**CITY OF LINWOOD
ATLANTIC COUNTY, NEW JERSEY**

**ALL WARS MEMORIAL PARK
FIELD HOUSE**

CONTRACT NO. 40

BID DOCUMENT ADDENDUM NO. 2

Figure 6H-20. Detour for a Closed Street (TA-20)

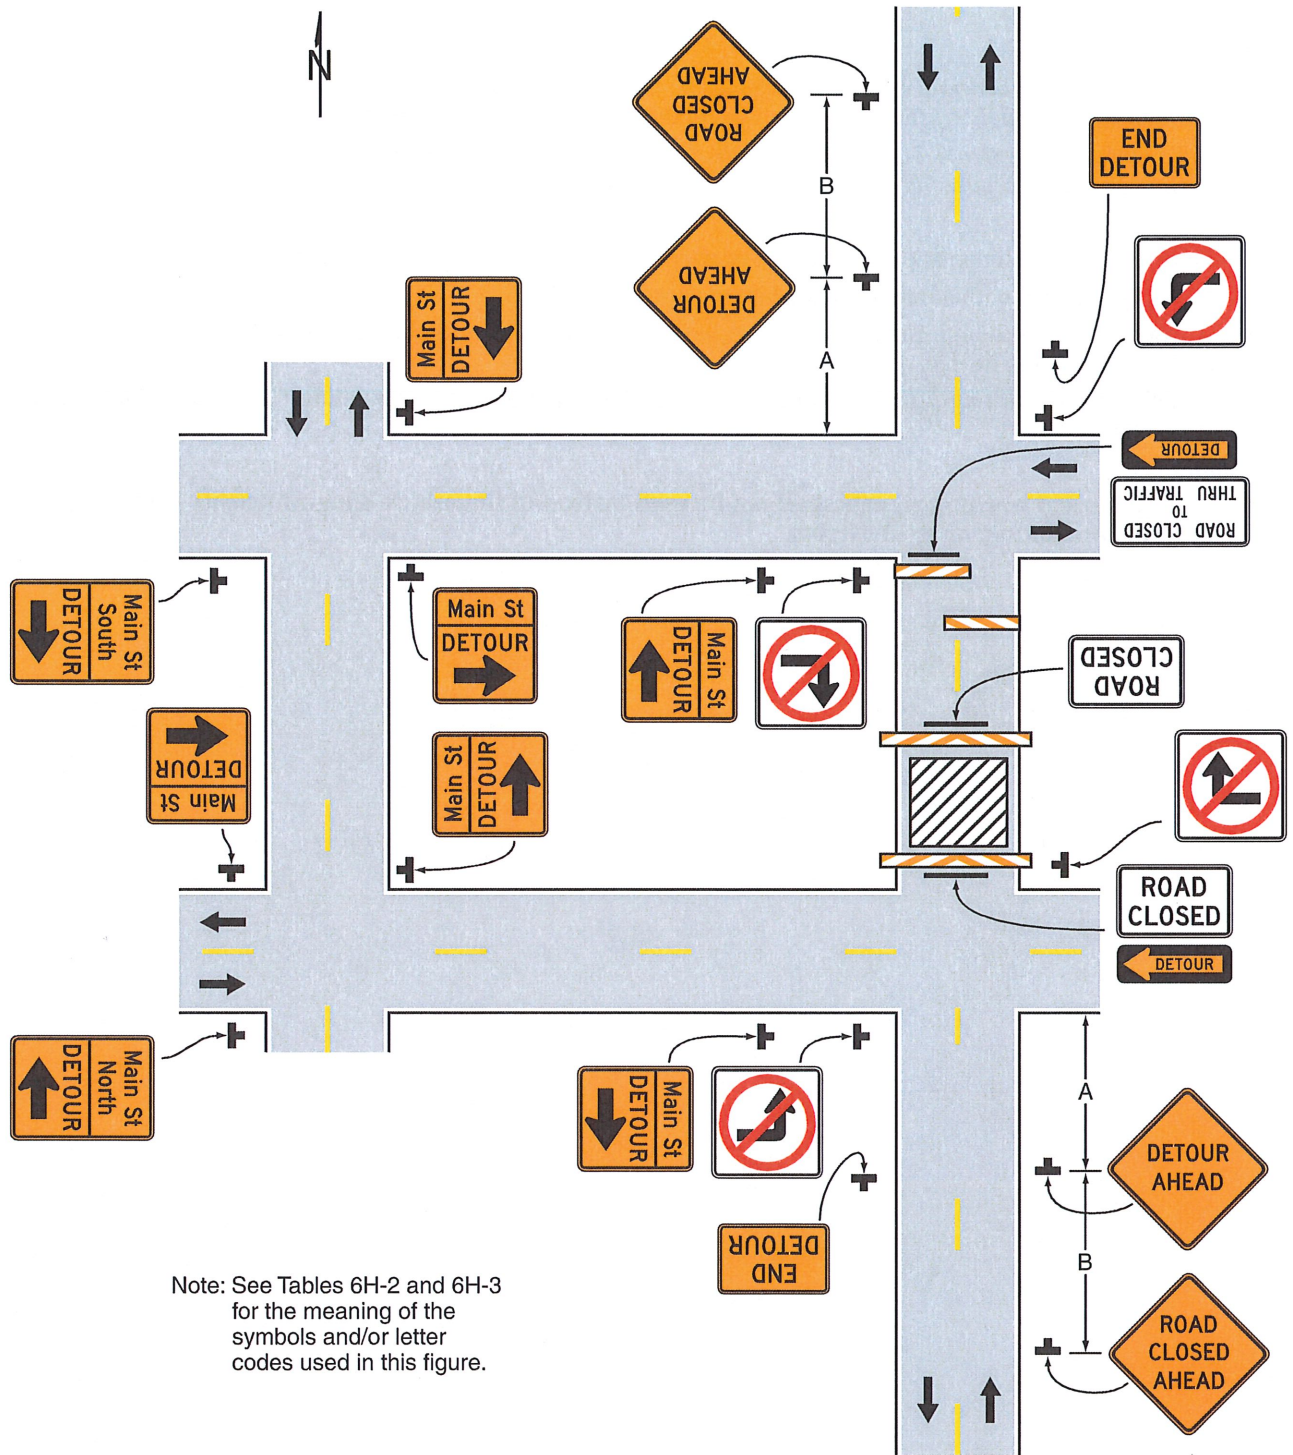
Will street protection be needed? Barricades, flashers, signage, crush vehicle, police attendance, by owner or GC?

The Contractor is responsible for the maintenance and protection of traffic. See Figure 6H-20, Detour for a Closed Street (Typical Application 20) from the MUTCD attached.
